REMARKS

Applicant has carefully considered the Examiner's Office Action and has amended the specification and the claims for the purpose of providing clarification, in view of the comments in the Office Action.

Fig. 2

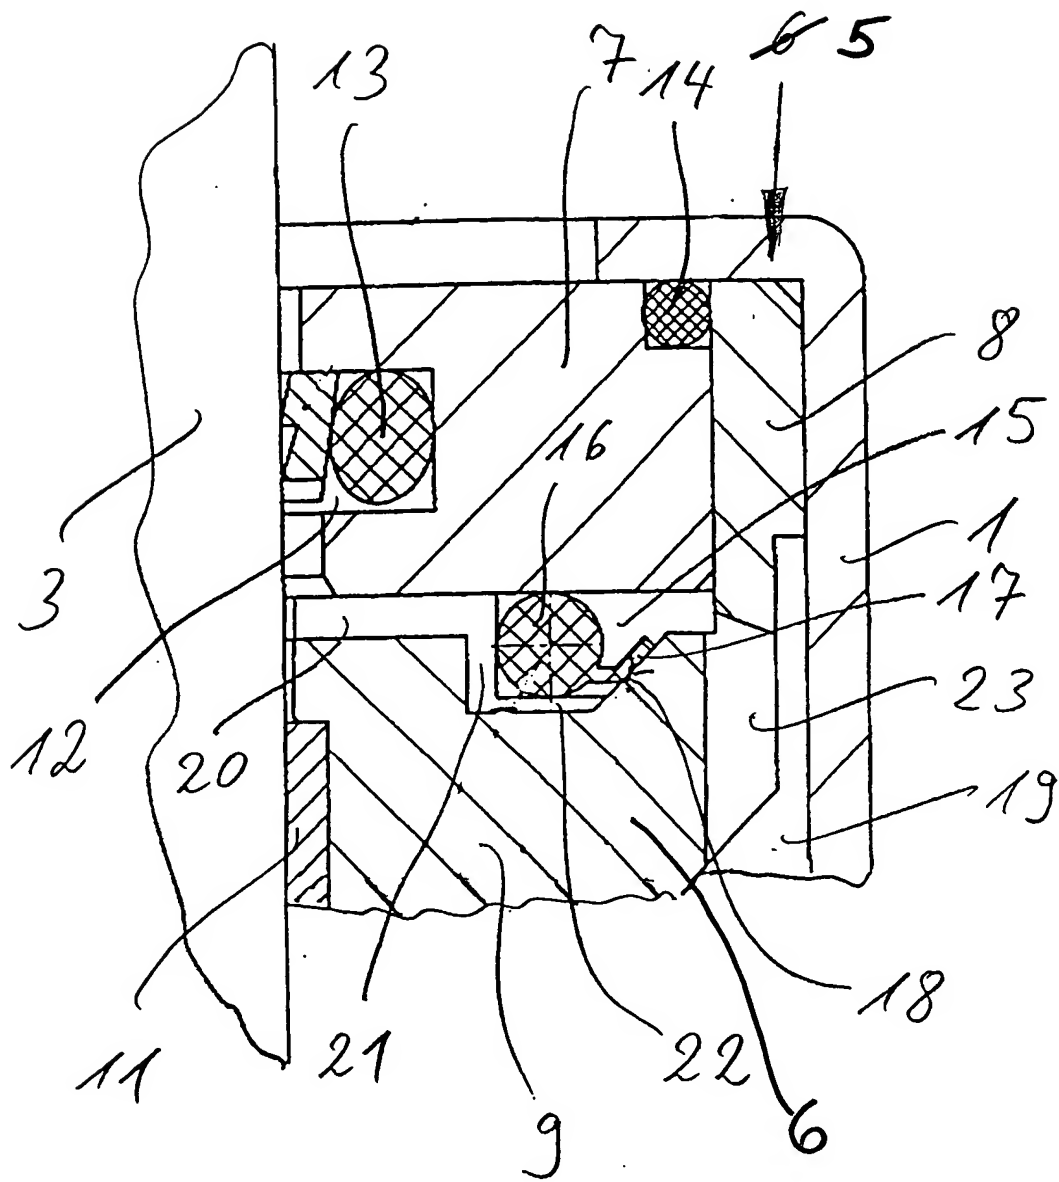
Thus, in considering the Examiner's comments and assumptions made with respect to the drawings, they appear to be based on an error in Figure 2. In Figure 2, the reference numeral 6 indicated there, should be correctly interchanged with the reference numeral 5, as noted in the amended and replacement drawing sheets that are being submitted. In Figure 2 considered by the Examiner, furthermore, the reference numeral 6 was omitted in error, and should designate the element as indicated in the amended and replacement sheets. Applicant notes, at the same time, that these reference numerals 5 and 6 are correctly shown in the drawing of Figure 1. As a result, no new matter is being introduced into the application through the present drawing amendment.

Furthermore, contrary to the Examiner's assumption, the "sealing seat" noted in the Office Action may not be considered as being located under the "circular ring 6", as noted by the Examiner in the Office Action. Instead, the "sealing seat" in applicant's invention is located on top of the piston-rod centering ring 6 and underneath sealing 16. This construction is shown in the corrected Figure 2.

In the Office Action on page 2, paragraph 1, last sentence, the Examiner comments that the views in Figures 1 and 2, "do not indicate that the cross-section of the circular ring is substantially circular shaped." From this comment, it is clear that the Examiner believes that reference numeral 6 designates a circular ring with a circular shaped cross-section. This, however, is not correct. Reference numeral 6 designates the "piston-rod centering ring 6," as shown in Figure 1 and by the corresponding section in applicant's specification. Thus, in applicant's specification on page 4, paragraph 2, sentence 3, line 15, as originally filed, describes "the wall of piston-rod centering 6 is approximately Z-shaped in cross-section."

In view of the preceding explanations, it is clear that the Examiner's correction requirements to the drawings are based on the Examiner's misinterpretations of the drawings. Apparently, these misinterpretations are partly due to the necessary interchange of the reference numerals 5 and 6 and the proper application of reference numeral 6 in the corrected drawing of Figure 2.

Applicant believes that in view of the corrections made to the drawing of Figure 2, the subject matter of applicant's invention is clarified and the assumptions made by the Examiner will be found to be based on misunderstandings of the Examiner in view of the following: By replacing the reference numeral 5 in the original drawing of Figure 2, with the reference numeral 6, and designating the piston-rod centering ring 6 that was omitted in error by the correct element as shown in the corrected drawing of Figure 2, it is believed that the Examiner will find the assumptions made in the Office Action to be incorrect.

is not correct. Instead, these portions are located at the top of the device.

It is noted, furthermore, that Figures 1 and 2 clearly show that the main cross-section of seal 16 is round and accordingly circular-shaped.

Applicant is submitting both amended sheets as well as replacement sheets for the corrected drawing of Figure 2, as required.
